ALBERTA TRANSPORTATION SPRINGBANK OFF-STREAM RESERVOIR PROJECT
RESPONSE TO NRCB AND AEP SUPPLEMENTAL INFORMATION REQUEST 1, JULY 28, 2018

Dam Safety
May 2019

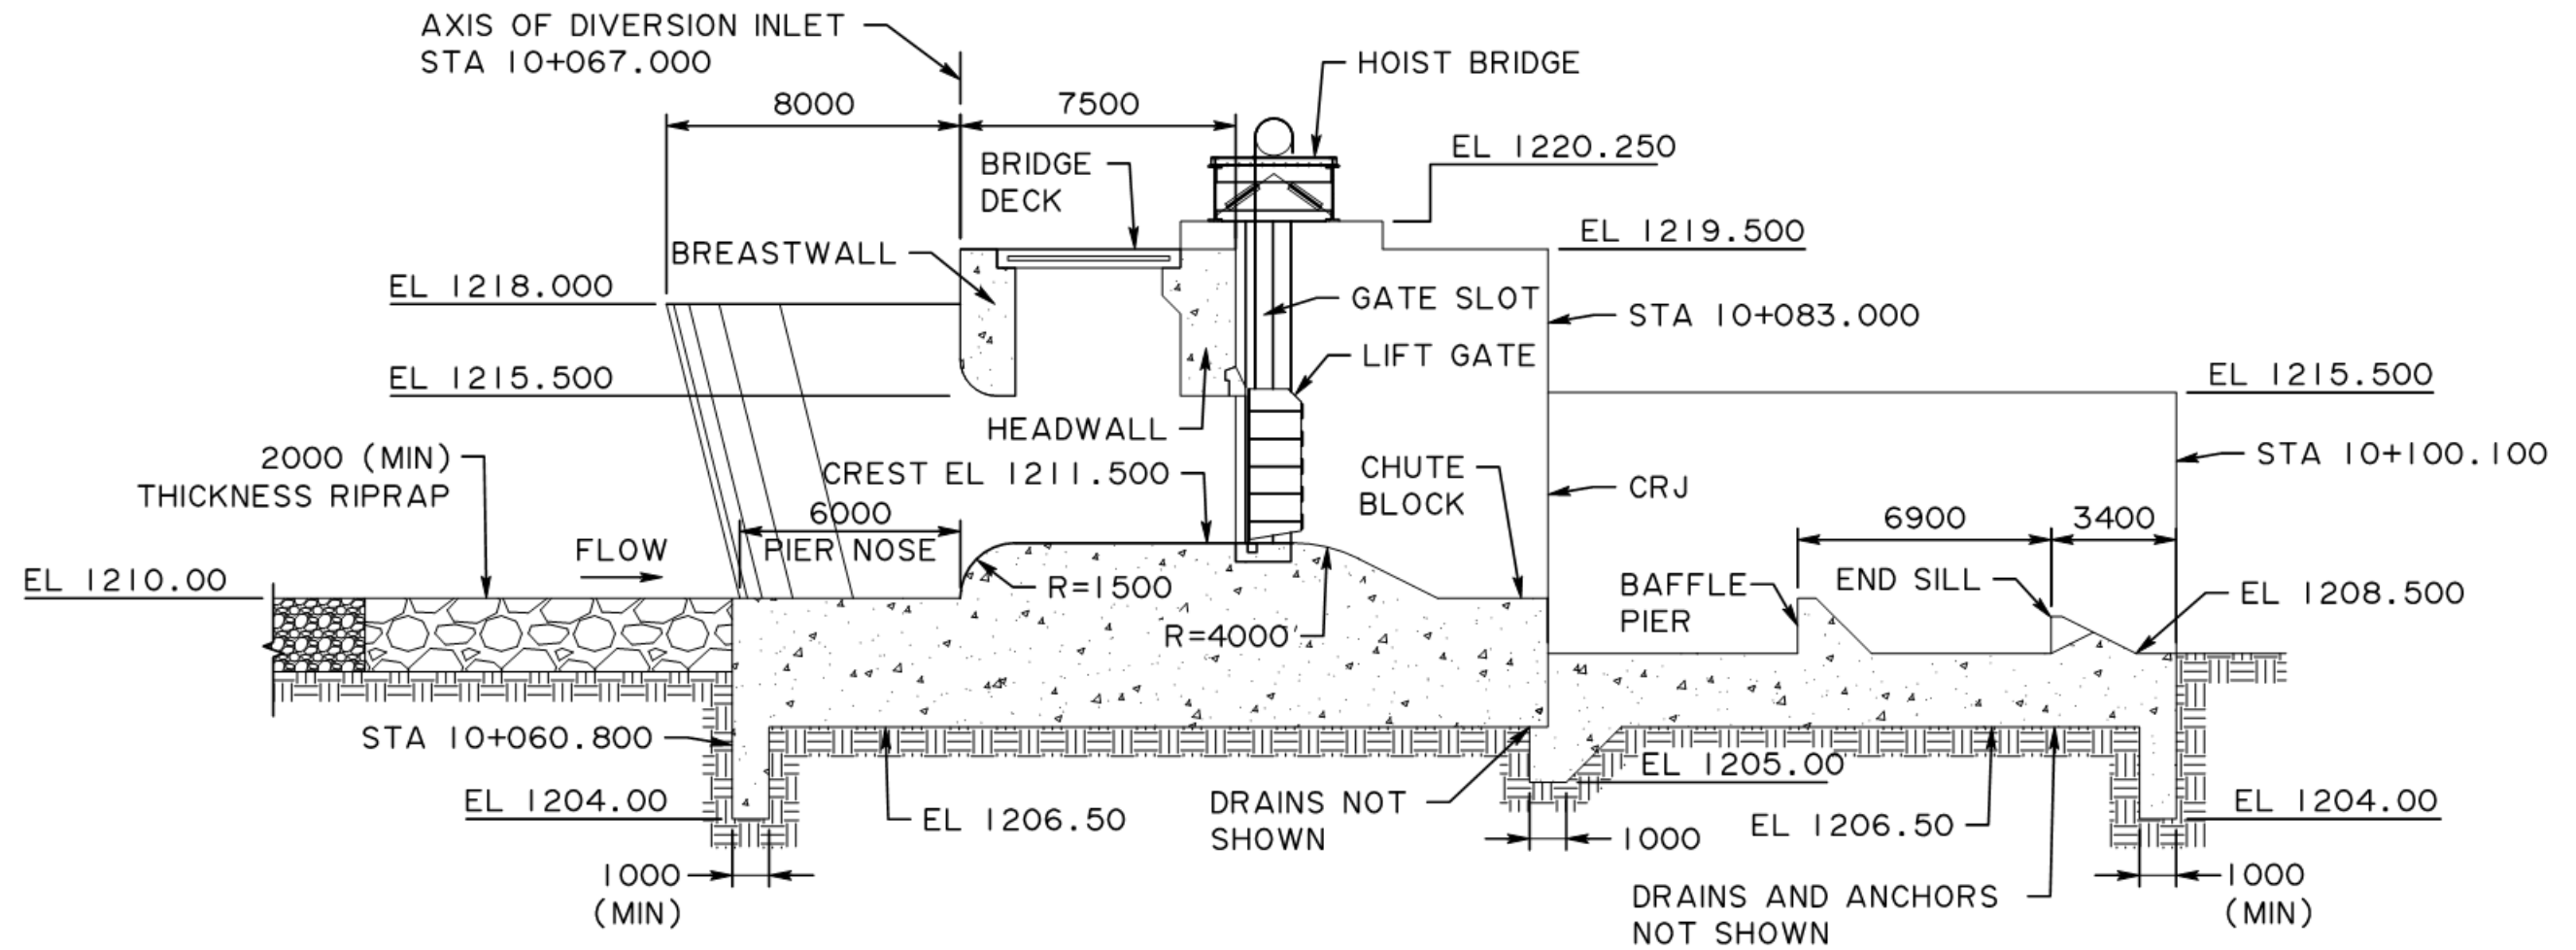
- a. Provide the design diversion capacity and water level, main structure components, and principal dimensions and elevations.
- b. Describe measures to prevent seepage/piping and drainage measures.
- c. Describe erosion protection measures (e.g. at entrance and downstream of the stilling basin).
- d. Describe construction requirements including temporary works (e.g. site clearing and grubbing, dewatering systems, foundation preparation, etc.).

- a. The diversion inlet is a concrete gate structure located on the left bank of Elbow River at the entrance to the diversion channel. The primary elements of the diversion inlet are:
 - left abutment, retaining walls, and embankment transitions
 - two 20 m wide gate-bays with a center pier-divider and fixed crest El. 1,211.5 m
 - two 20 m wide by 4 m tall vertical lift-gates with wire-drum hoist and hoist support spanning the 20 m bay width
 - access bridge—comprising bridge deck, breastwall, and headwall—that provides access to gate equipment, vehicle access across the diversion channel entrance, and it is a debris and overtopping barrier during extreme flood events
 - stilling basin with chute blocks and end sills to provide energy dissipation and minimize channel erosion
 - right abutment, retaining walls, and embankment transitions

A cross section through the centerline of the diversion inlet is presented in Figure IR456-1. The design maximum discharge capacity (600 m³/s) is calculated to occur at headwater El. 1,215.8 m.

Figure IR457-1 Service Spillway Gate Rating Curve (24 m Wide Bay)

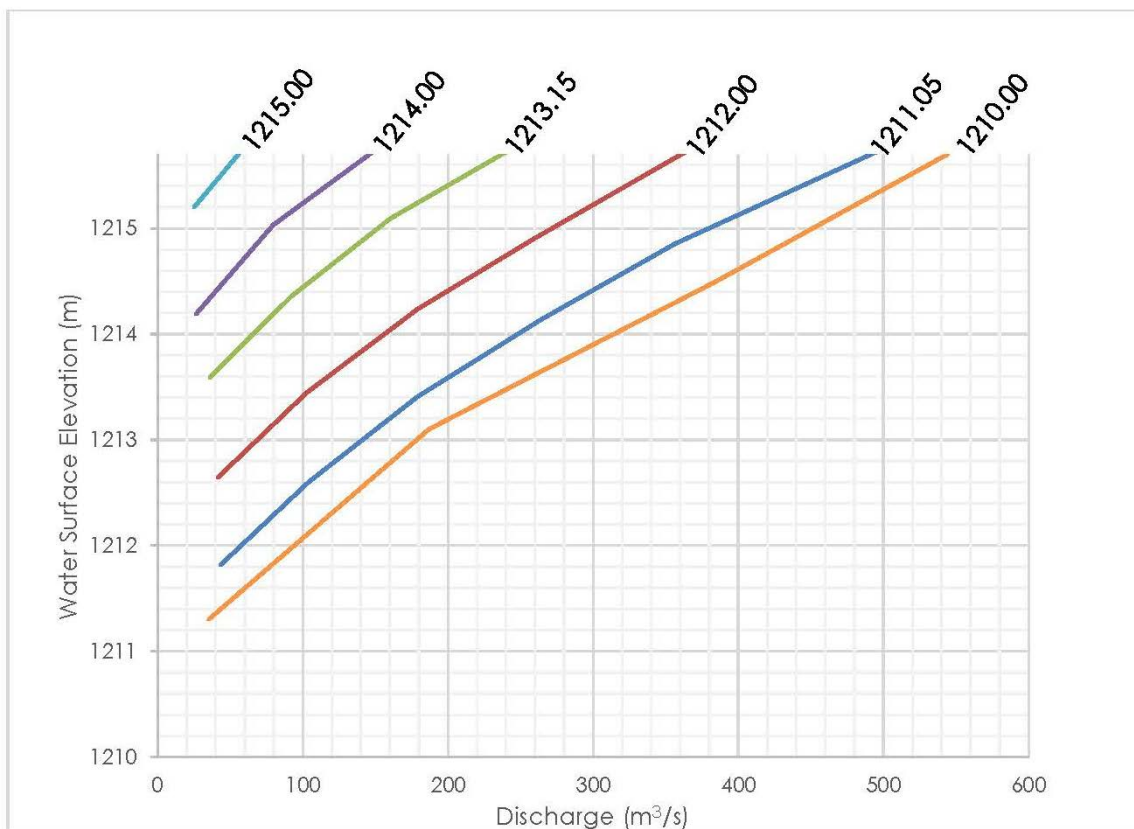
- a. Provide the design discharge capacity (e.g. gates down) and design water levels (e.g. gates down and gates in operation).
- b. Describe the main structure components and provide the principal dimensions and elevations.
- c. Describe measures to prevent seepage/piping and drainage measures.
- d. Explain the reasons for backfilling the stilling basin with native substrate. Does this have to be maintained?

- a. A series of rating curves was developed for the service spillway for six gate positions, based on results of the physical model and numerical models. Figure IR457-1 provides the relationship between headwater elevation and discharge for the six corresponding gate positions for a single 24 m bay.

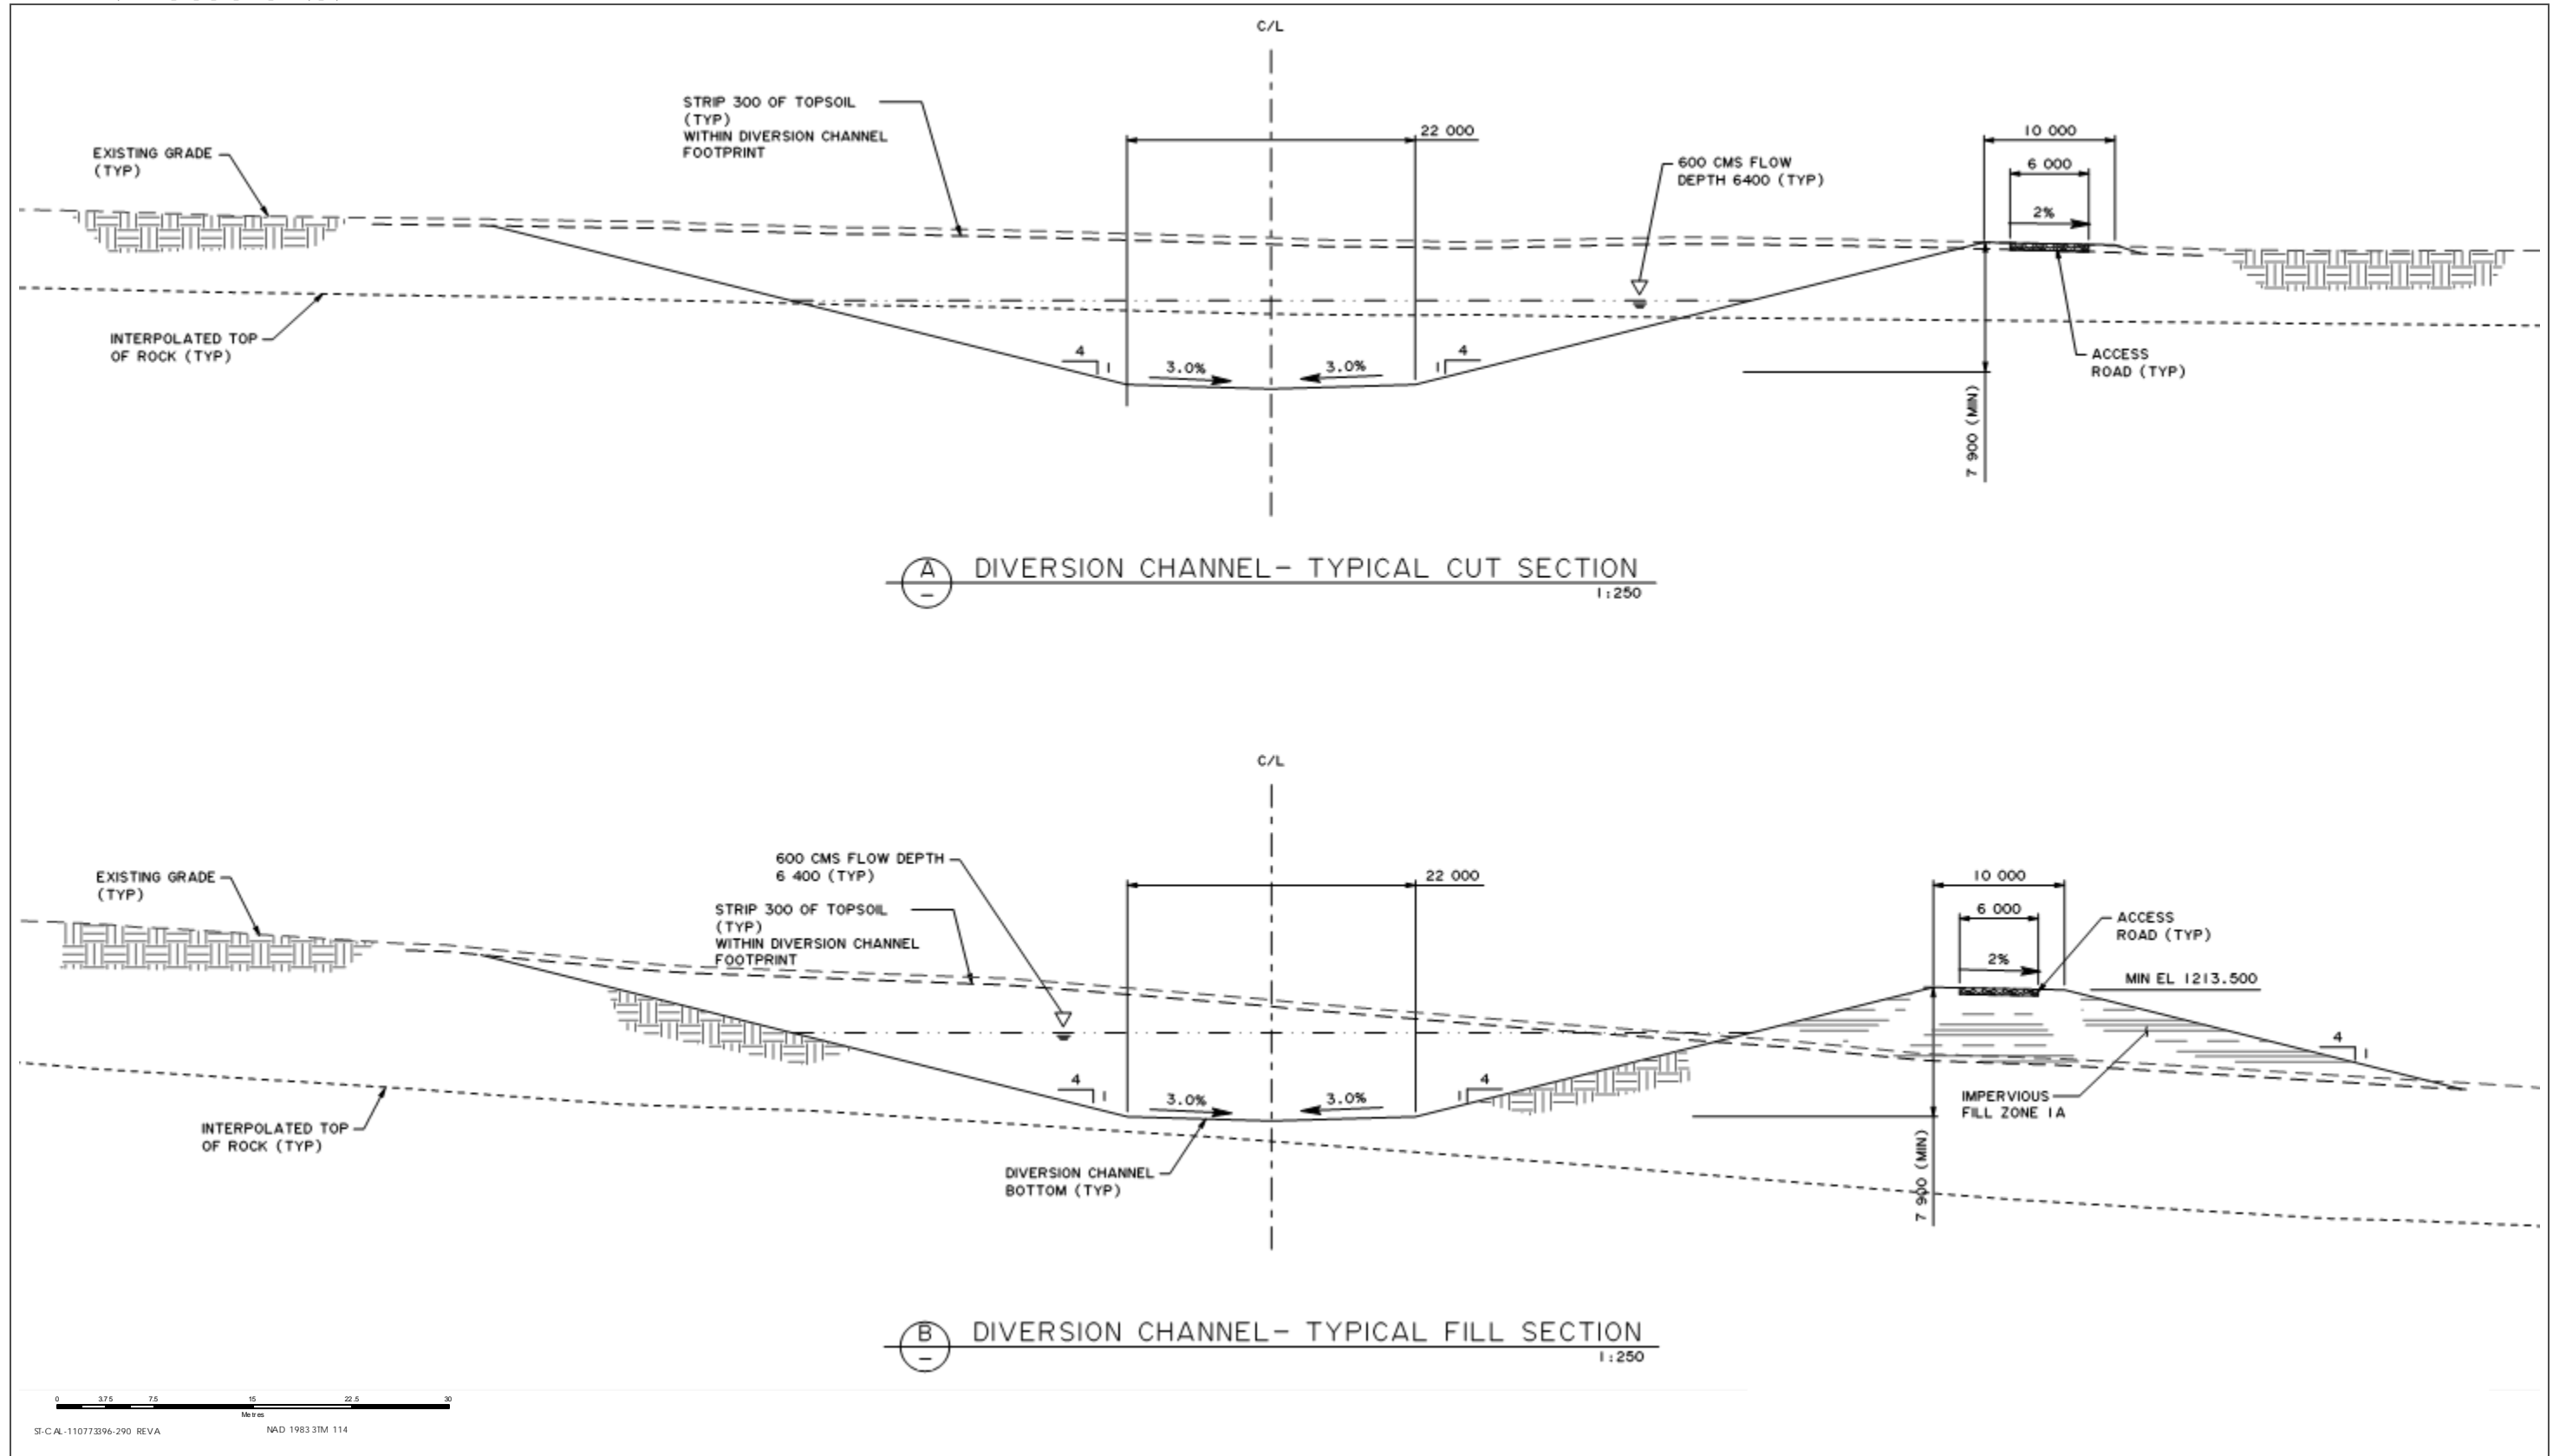
- e. Provide typical design cross sections in cut and fill.
- f. Describe the excavation and stockpiling requirements.
- g. For the two bridges across the diversion channel, explain if large debris that finds its way past the diversion inlet can collect at the bridge piers and block the channel.

- e. Figure IR463-1 provides typical diversion channel sections in cut and fill sections. These are representative for the channel through rock and/or soil.

Figure IR465-1 Reservoir Drawdown from Full Service Level

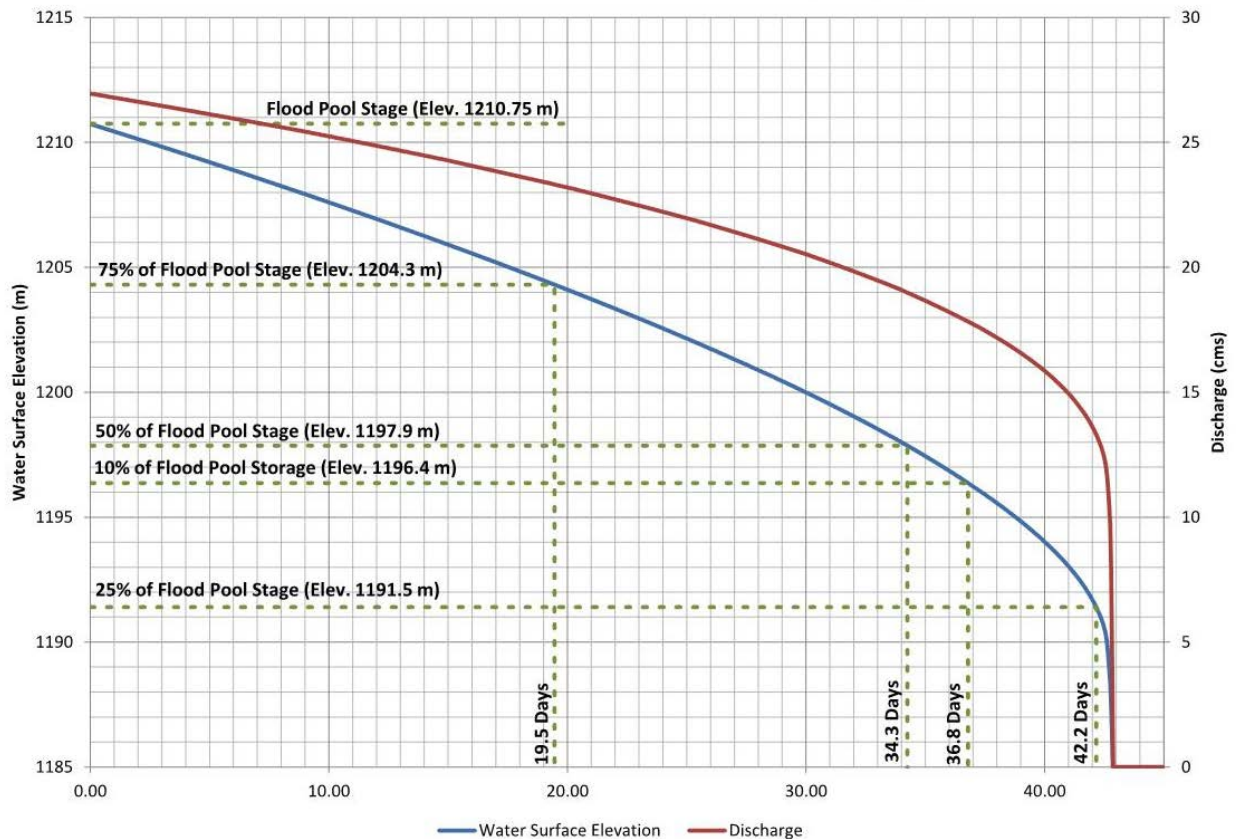
- a. Why are the residence and release times for the larger 2013 flood less than that for the 1:100 year flood?
- b. Explain the reservoir evacuation criteria (e.g. levels and times) in case of an emergency at the dam, that are being used.
- c. Provide the reservoir's operating rules with actual filling and releasing times/rates/levels corresponding to various flood events and conditions.

Figure IR465-1 presents the drawdown rates for the off-stream reservoir with the prescribed flood pool stage identified. The blue line on the figure represents the reservoir stage over time. At each of the defined criteria stages, the elevation and drawdown time are noted. As an example, the 75% stage (El. 1,204.3 m) is achieved in 19.5 days, which meets the minimum criteria of 20 to 30 days.

Figure IR468-1 Seepage Gradients for Sta. 22+925

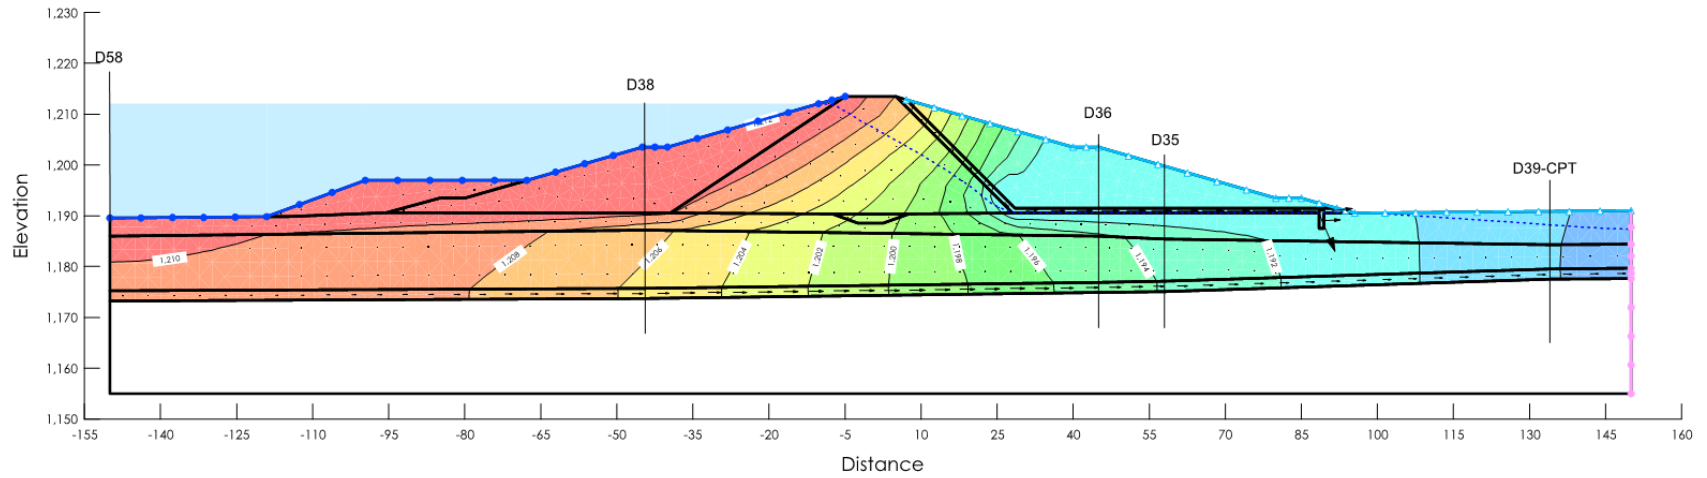
- a. Provide a discussion on foundation materials underlying the dam and saddle dyke including what seepage control requirements are necessary and how these requirements might vary across the bottom of the valley and abutment areas. Describe or show the typical dam cross sections in the vicinity of the low level outlet near the No Name creek channel.
- b. Explain why a nominal cutoff trench would be sufficient for part of the dam when a deep cutoff trench is required for the floodplain berm on the Elbow River and drains are proposed near the low level outlet structure.

Results of the seepage analysis for the typical cross section underlain by GL/GT is shown in Figure IR468-1.

Figure IR475-1 Preliminary Rating Curve for Low Level Outlet Works

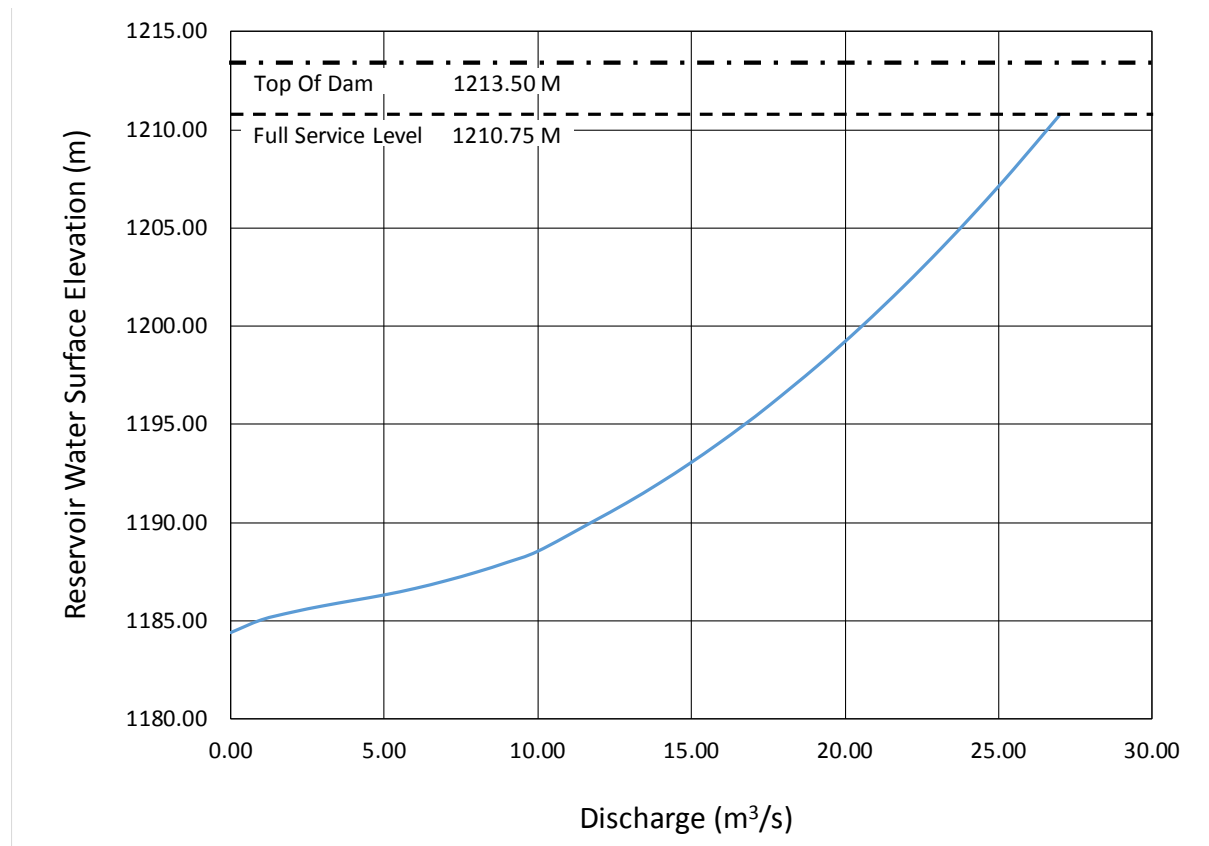
Alberta Transportation states that *The low-level outlet structure (Figure 3-10) consists of an approach channel, discharge gate, gatehouse, discharge conduit and outlet channel. The gate is operated locally by the gatehouse. Figure 3-10 is labeled Low Level Outlet but only shows the basin at the downstream toe. The photo in this figure is a picture of another project with a similar basin but with twin conduits that are round instead of the actual conduit shape for this project.*

- a. The preliminary rating curve for the low-level outlet works (LLOW) is provided in Figure IR475-1.
